UNITED STATES PATENT AND TRADEMARK OFFICE

APPLICATION NO.	FILING DATE	FIRST NAMED INVENTOR	ATTORNEY DOCKET NO.	CONFIRMATION NO.
10/506,287	08/31/2004	Henricus Marinus Josephus Hikspoors	NL 020186	6744

Office Action Summary

DETAILED ACTION

FIG 19

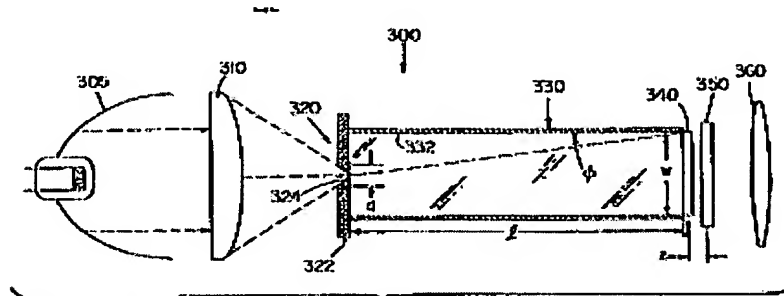
4. Swanson discloses and shows in Fig. 19, a projection device for projecting an image comprising a light source (305) for emitting light, a transmissive LCD projection subsystem and a projection means (360) for projecting the image, the projection subsystem comprising:

- a waveguide integrator (330) for guiding light from an entrance to an exit, the inner entrance surface of the integrator being coated with a reflective material

(322) and having a hole (324) for coupling light emitted from the light source into the integrator; and

- a transmissive LCD (350) provided at the exit side of the integrator.

Swanson differs from the claimed invention because he does not explicitly disclose the claimed reflective polarizer at the exit surface of the integrator.

As to claim 5, Swanson shows in Fig. 19 that the waveguide integrator further comprises retardation film (340) for changing the polarization of the polarized light back into the integrator.

As to claim 8, Swanson also discloses that the integrator (330) is made of higher refractive index material for reflecting light (col. 18, lines 5-7).
